City of Portland, Maine – Building or Use Permit Application 389 Congress Street, 04101, Tel: (207) 874-8703, FAX: 874-8716

Location of Construction: 66 Bramblewood Dr		Owner: Kazilonis		Phone:		Permit No. 960760	
Owner Address:		Leasee/Buyer's Name:		Phone:		Business Name:	
Contractor Name: Daniel Kennedy		Address: 15 Devonshire Pt. Rd, ME 04101		Phone: 773-7986		<div style="border: 2px solid black; padding: 5px; text-align: center;"> PERMIT ISSUED Permit Issued: AUG - 6 1996 CITY OF PORTLAND </div>	
Past Use: 1-fam		Proposed Use: Same		COST OF WORK: \$ 1,650.00 PERMIT FEE: \$ 30.00 FIRE DEPT. <input type="checkbox"/> Approved <input type="checkbox"/> Denied INSPECTION: Use Group <i>R3</i> Type <i>53</i> Signature: <i>[Signature]</i>			
Proposed Project Description: Extend Deck		PEDESTRIAN ACTIVITIES DISTRICT (P.A.D.) Action: <input type="checkbox"/> Approved <input type="checkbox"/> Approved with Conditions <input type="checkbox"/> Denied Signature: _____ Date: _____		Zoning Approval: <i>R-2</i> CBL: 377-7-011 Special Zone or Reviews: <input type="checkbox"/> Shoreland <input type="checkbox"/> Wetland <input type="checkbox"/> Flood Zone <input type="checkbox"/> Subdivision <inpu

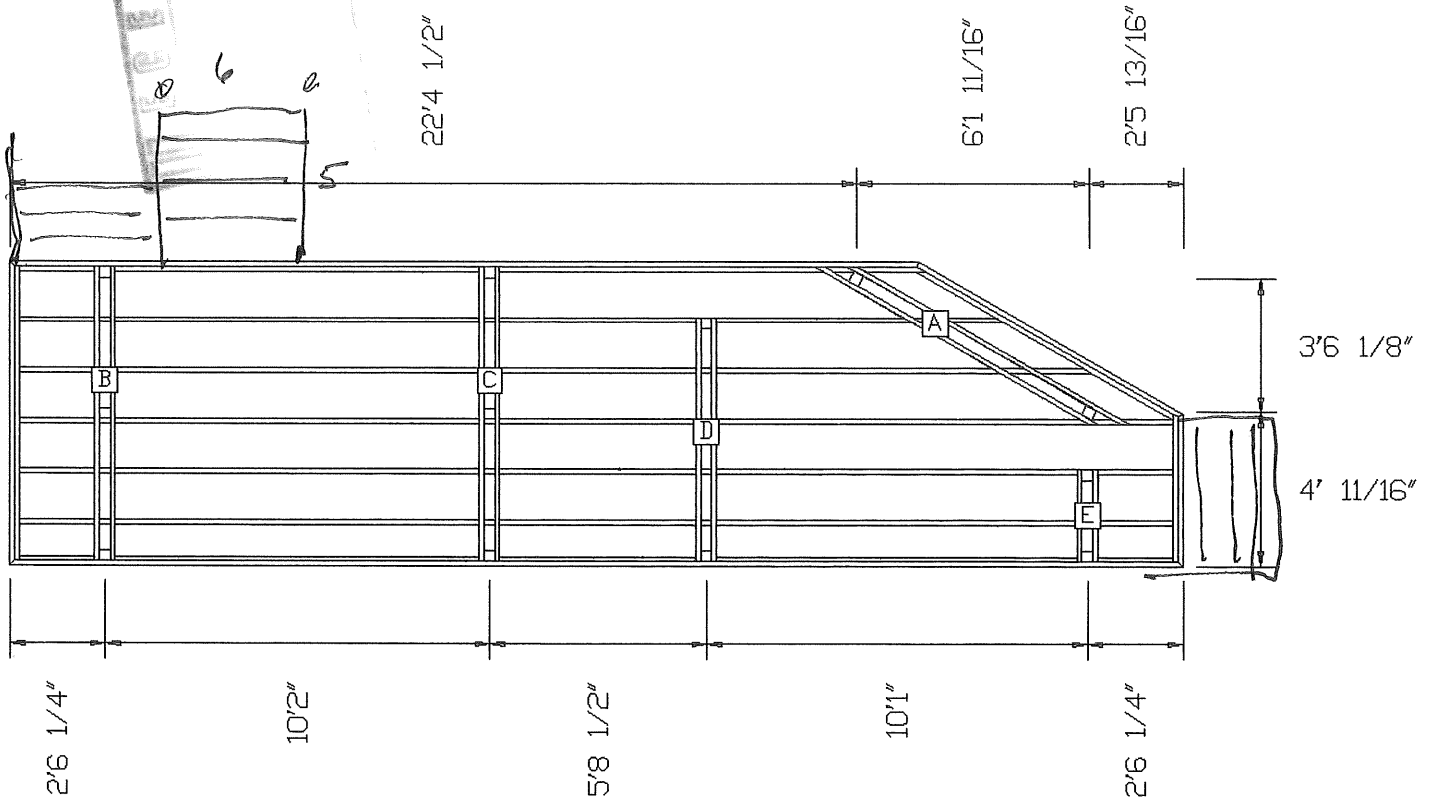
R-5

rear setback - 25' min - 50' + shown

side yard setback - 12' req - 15' shown

lot size 14,496 # x 20% = 2899.2 #

22x24 = 528

24x28 = 672

9x12 = 108

12x18 = 216

1524 # New
